<b>Docket Number:</b>	25-BSTD-03
<b>Project Title:</b>	2028 Energy Code Pre-Rulemaking.
<b>TN #:</b>	266006
<b>Document Title:</b>	Meg Waltner Comments - NRDC Comments on August 28th Title 24 2028 Energy Code Accounting Workshop
<b>Description:</b>	N/A
<b>Filer:</b>	System
<b>Organization:</b>	Meg Waltner
<b>Submitter Role:</b>	Public
<b>Submission Date:</b>	9/12/2025 3:21:33 PM
<b>Docketed Date:</b>	9/12/2025

**NRDC Comments on August 28th Title 24 2028 Energy Code  
Accounting Workshop**

Re: Comments on the 2028 Building Energy Efficiency Standards Energy Accounting Methodologies

**Figure 14 - Energy Use Comparison (Single-Family Prototype)**

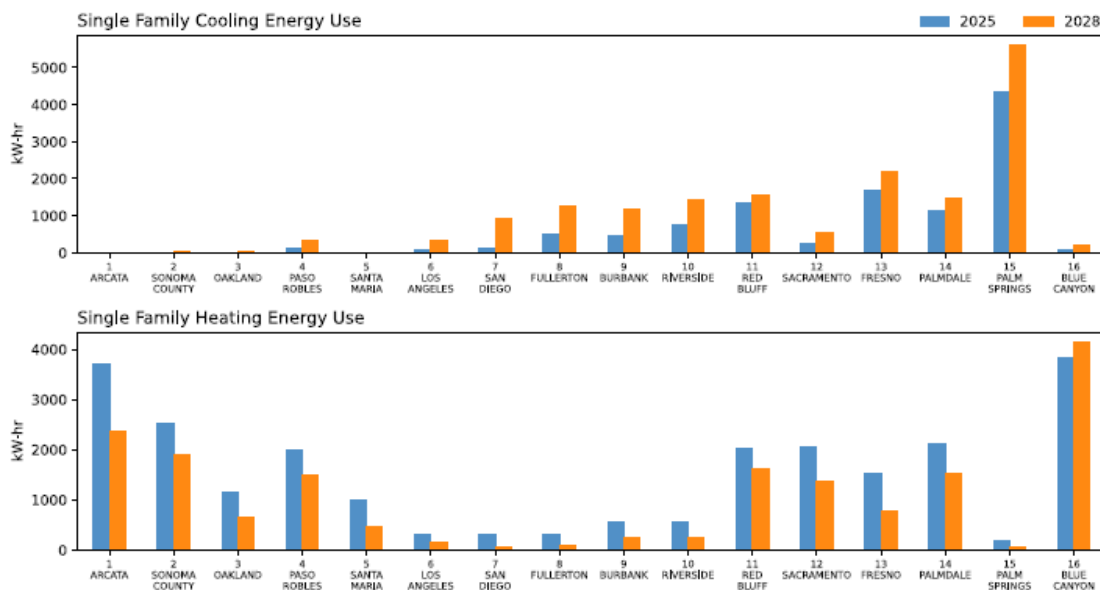
NRDC strongly supports the California Energy Commission’s proposal to update weather files to better represent future climate conditions. Weather files are a foundational input to the energy code, influencing both weather-dependent measures and the LSC and source energy metrics. For the first time, the CEC is developing future weather files that reflect the projected future climate conditions that buildings are likely to experience, rather than relying solely on historic data. These new files, based on LOCA2 climate model projections, select representative past months from California’s historic TMY dataset that best align with likely future conditions. The resulting future TMYs preserve realistic hourly weather patterns while reflecting the broader climate trends expected for 2030–2059. The future weather files show that California buildings will face more cooling degree days and fewer heating degree days. These changes impact energy use, equipment sizing, and measure selection and it is therefore important to have representative weather data underlying these analyses. We note that the reduced number of heating degree days does have the potential to reduce savings available for heat pumps (due to lower heating loads). However, we continue to support the use of future weather files since they are more representative of the conditions buildings affected by the code are likely to experience. The following figure shows how the updated weather files are likely to impact single family cooling and heating energy. As expected, heating energy decreases in almost all climate zones and cooling energy increases under overall warmer future weather conditions.

NRDC has advocated for multiple code cycles that building code decisions should be grounded in the future weather that buildings are likely to encounter during their lifetimes, rather than in the historical climate. The use of the updated future weather files will provide a more accurate assessment of efficiency measures and technology choices, ensuring that the building code continues to deliver real-world benefits under changing climate conditions. We

Figure 1: Proposed Typical Classroom Occupancy Schedule

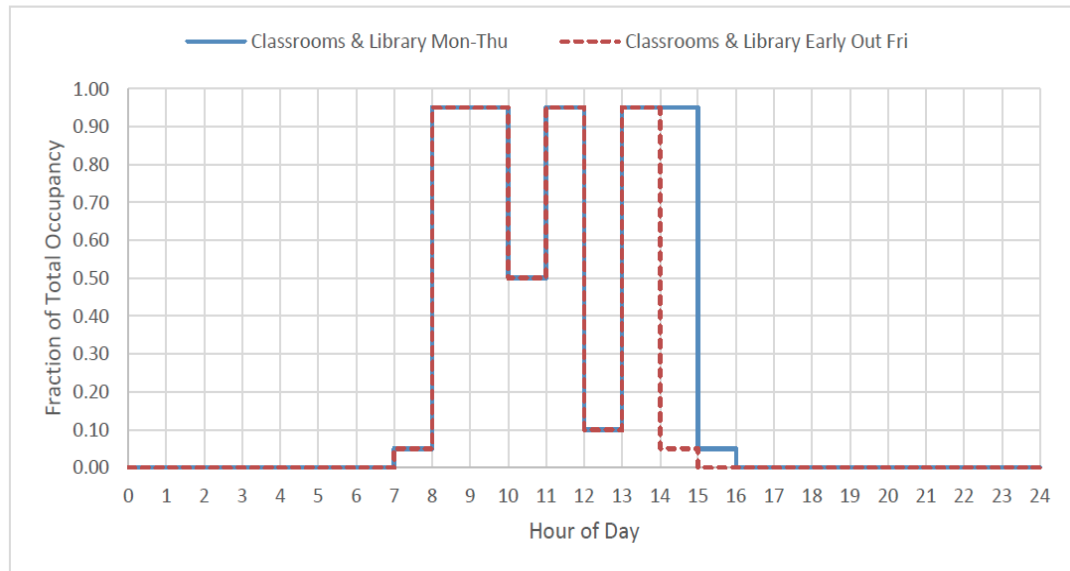
- *Update school occupancy schedule to reflect hours that the HVAC and lighting systems are likely to be operational even if classroom activities are not scheduled.* The CEC has proposed updates to the school occupancy schedules (which underpin building energy load and cost-effectiveness analysis) to be more reflective of current school schedules. However, in doing this, the CEC has been overly aggressive in assuming that school occupancy goes to zero or near zero to align with those school schedules. An example of this is the following schedule, which assumes the classroom goes to an occupancy fraction of 0.05 at 3 PM, 0 by 4 PM, and 0.1 for an hour at lunch.

This schedule does not reflect the fact that schools are rarely fully off during business hours – janitors and maintenance staff work during this time, after school programs run for parents who work until the end of the typical business day, teachers do work in their classrooms when students aren't present, student activities or clubs meet in classrooms, and after-hours events are held. These extended hours are particularly true for high schools, where many after-hours activities are occurring. During the summer, summer school, camps, and other secondary uses can also lead to additional occupancy. While the CEC has attempted to account for these events, assuming the schedule goes to 0 or 0.1 before the end of the typical business day is overly aggressive. Similarly, assuming the occupancy fraction goes to 0.1 at lunch time does not reflect the fact that students and teachers may still be present in the classroom during lunch time and therefore the loads in those spaces are unlikely to drop so significantly. We recommend that the CEC make adjustments to the occupancy fraction for schools to better reflect partial use of school facilities during business hours. In the absence of better data, an occupancy fraction of somewhere between 0.25 to 0.4 for all standard business hours during the school year would seem more reasonable.

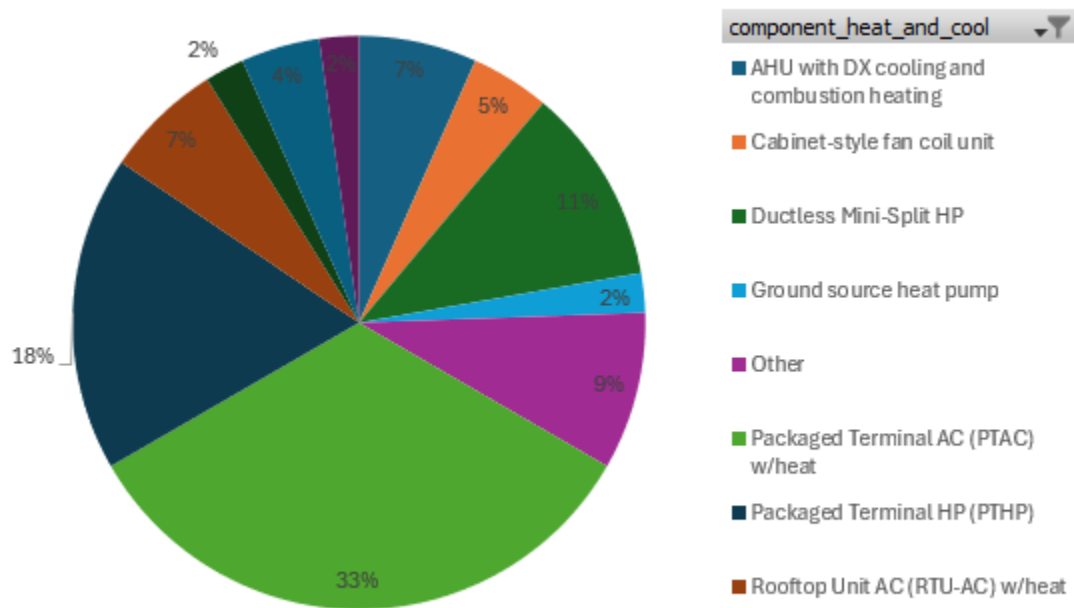
➤ *Consider changing the baseline system type for large hotels to something more representative.* The CEC proposes using a four-pipe fan coil system with central gas boiler and chiller as the baseline system type for the new large hotel prototype. While the report states that this decision is based on review of the California End-Use Survey (CEUS), there do not appear to be publicly available results from the CEUS indicating end-use HVAC system type for hotels (although the survey does collect this information). From our experience, four-pipe fan coils are a less common system type

for lodging facilities. From a review of the Northwest Energy Efficiency Alliance's (NEEA) 2019 Commercial Building Stock Assessment (CBSA), packaged terminal air conditioners and heat pumps (PTACs/HPs) appear to be much more common for large hotels. The following chart summarizes the penetration of each system type found in the CBSA data by number of buildings for lodging greater than 59,000 square feet and shows fan coil units representing just 5 percent of buildings. We recommend that the CEC update the baseline HVAC system type to something that is representative of typical construction and ensure that the chosen baseline does not inhibit the installation of all electric HVAC systems in large hotel buildings.

**Figure 13: Office - Impacts of Proposed Changes on LSC**

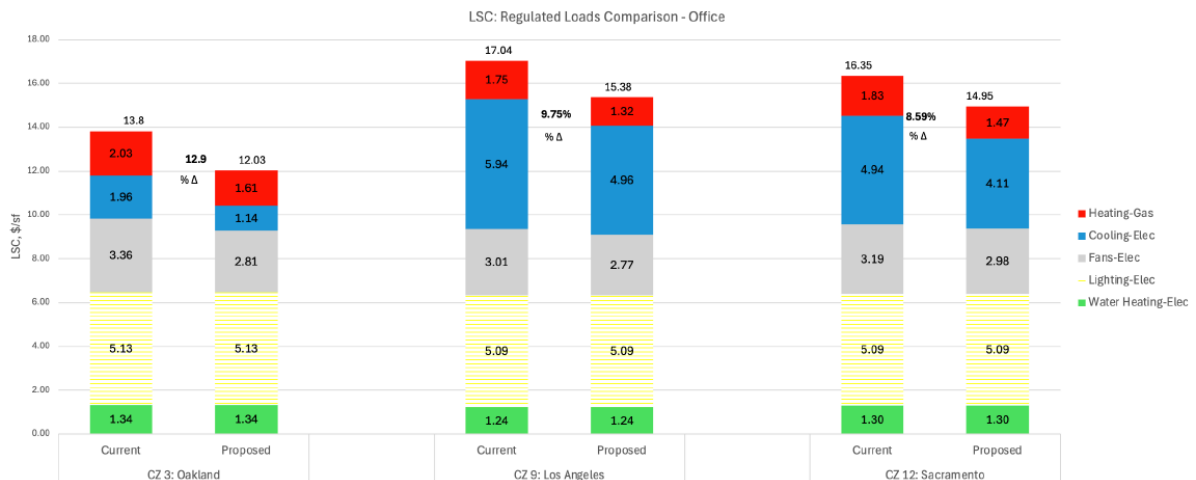
- The office EPDs decreased significantly, which we support – plug load energy use has decreased significantly since these assumptions were developed. However, the CEC’s modeling indicated that this reduced both heating and cooling energy use as shown in the graph below. This result is counterintuitive as we would expect reduced office EPDs to decrease cooling energy and increase heating energy, rather than decreasing both. Our understanding is that this may be because while EPDs have gone down, the off-hour load fraction has increased, increasing nighttime loads and decreasing heating use. While this result makes sense, it does not seem correct that overall heating loads would have decreased in buildings over the last 20 years due to an increase in plug load energy (i.e. even though EPD has gone down, total cumulative load has gone up). This is important because underestimating this heating energy load could affect the cost-effectiveness of heat pumps. We recommend that the CEC evaluate this impact, particularly how it might affect the implementation of heat pumps.

**Figure 18: Analysis and Proposed Updates to Office Receptacle Schedule (Weekdays)**

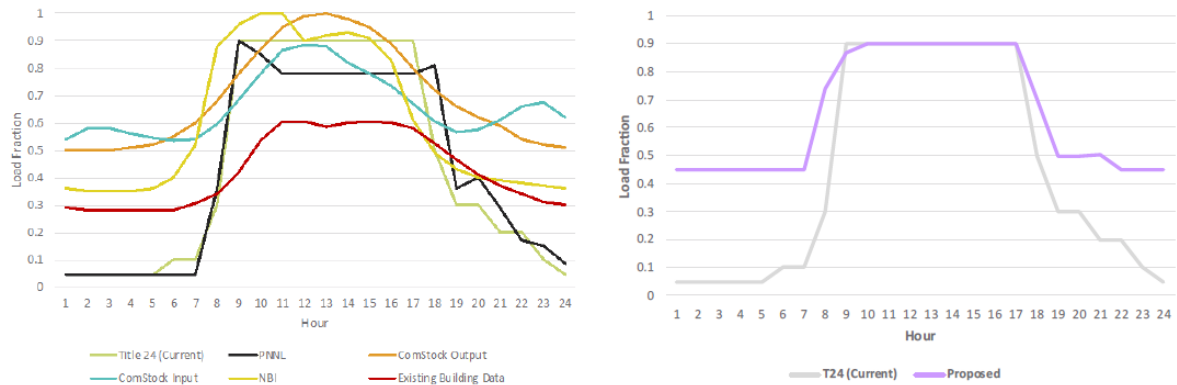
- We are concerned that the off-hours load fraction for office receptacles shown in the figure below is too high. The CEC has proposed increasing this load fraction from 0.05 to 0.45. While we agree an increase is warranted, almost 50% seems high for an after-hour load fraction, especially given that most office workers bring computers home on a daily basis, particularly in a hybrid work environment. While we agree that updating these values based on the latest data makes sense, we are concerned that the revised ComStock schedules (shown in blue and orange in the left-hand chart below) are over inflating these numbers and think that relying on the PNNL and/or existing building data profiles would be more representative.
